MONITORING YEAR 4 ANNUAL REPORT

BIG HARRIS CREEK MITIGATION SITE

Cleveland County, NC
DMS Project No. 739
DEQ Contract 006256
DWR 401 Project No. 10-0811
USACE Action ID No. SAW-2009-0475
Broad River Basin
HUC 03050105

RE: Big Harris Creek Mitigation Site – Monitoring Year 4 Report
Final Submittal for DMS
Contract Number 006256, RFP Number 16-006119, DMS# 739
Broad River Basin – CU# 03050105; Cleveland County, NC

Monthly Rainfall Plot

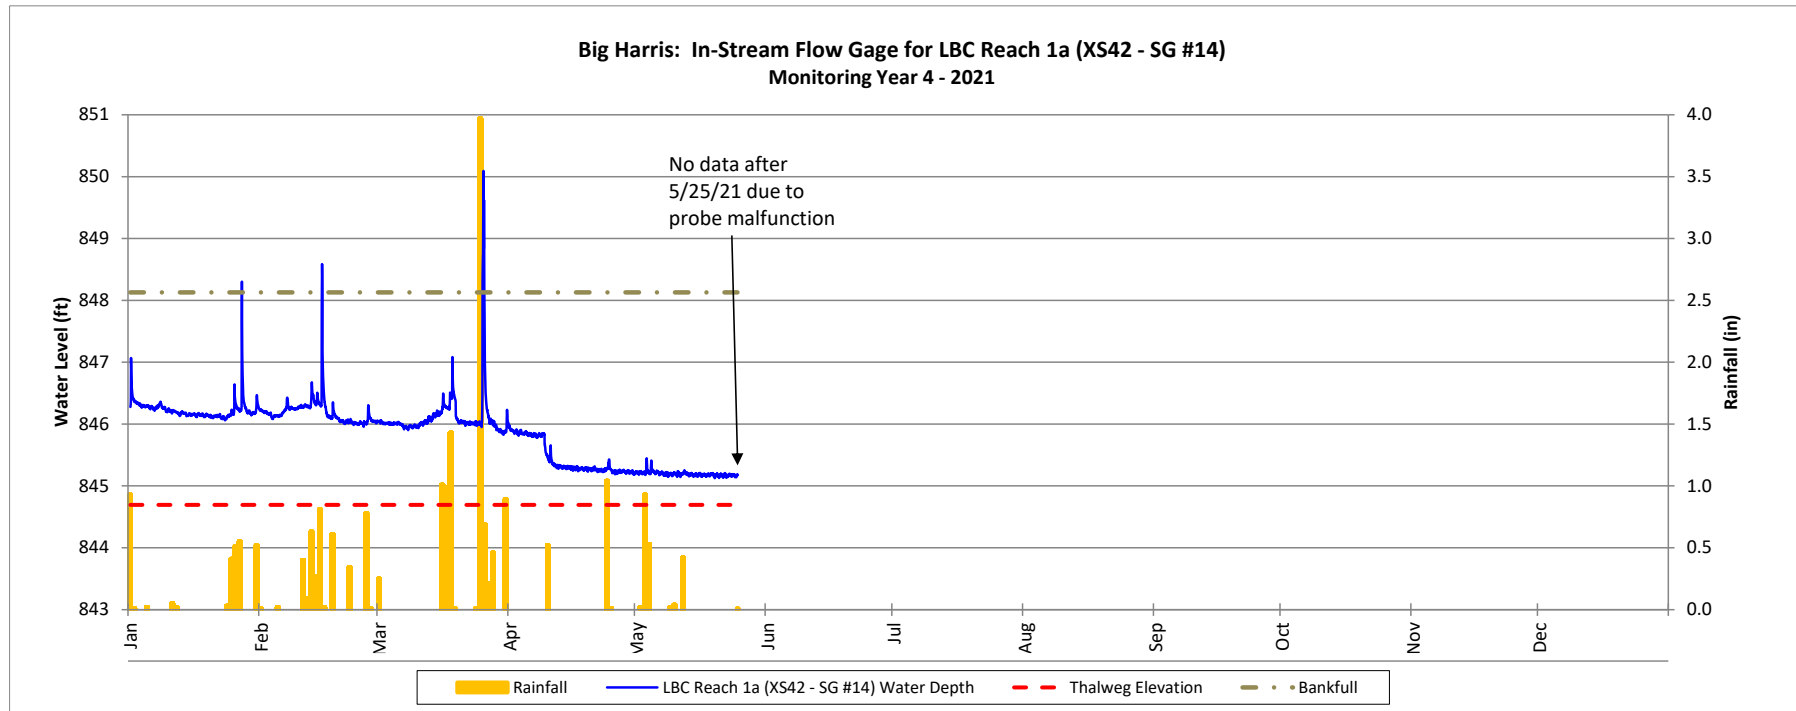
DMS' Comment: Appendix 5. Hydrology Summary Data and Plots – Please specify the source of precipitation data.

Wildlands' Response: The source of the precipitation data is USGS Station 02150495 located along the Second Broad River near Logan, NC. A reference has been added in the report and included on the newly created Monthly Rainfall Plot in Appendix 5.

30th and 70th percentile rainfall data collected from WETS Station Shelby 2 NW in Shelby, NC (USDA, 2000).

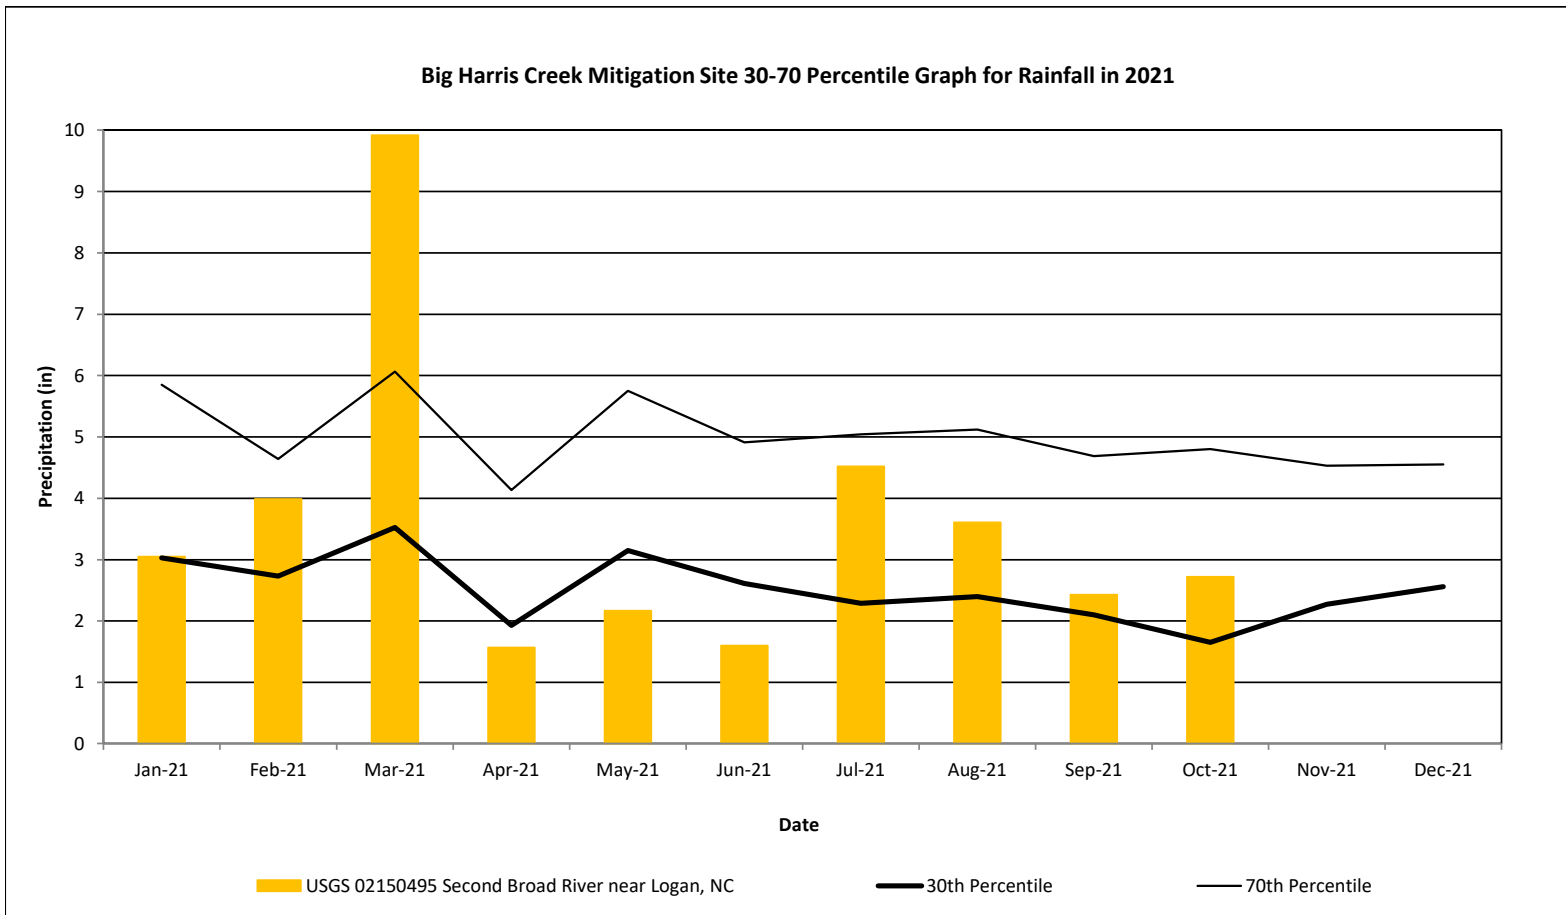
DMS' Comment: Digital Support Files – In the report and support files, please include a figure with the 30th and 70th percentiles of monthly precipitation relative to observed precipitation.

Wildlands' Response: A chart with the 30th and 70th percentiles of monthly precipitation relative to observed precipitation has been added to Appendix 5.
